SUBJECT: Addendum 3 to Quote Request, 39361 – Refurbish Walkways/Platforms In Upper Basin

Indian River and Brevard County

Figure 4: **SLWMA** – S-262 WALKWAY DIMENSIONS:

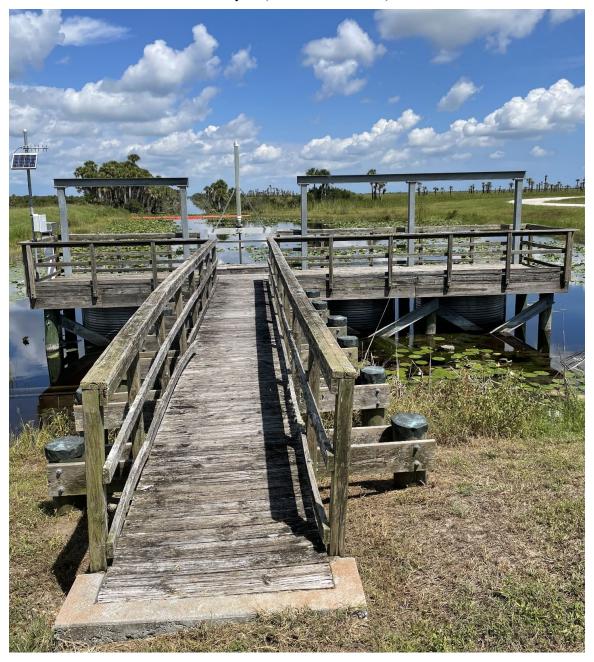
7. **Question:** Dock S-262 has a facia below the stringer, is this getting replaced?

9. **Question:** Your quote sheet references 1 BCWMA, 2 SLWMA, and 3 FDMCA to insert quote pricing, but the scope and pictures don't S262 Walkway as SJMCA not Sawgrass Lake SLWMA which is on the quote sheet?

As indicated in Figure 4: SJMCA – S-262 WALKWAY, the areas being replaced will be the walkway, supports, and handrail. Once the decking is removed the fascia will be evaluated and if repairs are required, these will be handled as a change order.

The quote sheet referencing #2, Sawgrass Lake Water Management Area (SLWMA), is correct. Please see attached Figure 4, Figure 5, and Figure 6 with corrected reference SLWMA.
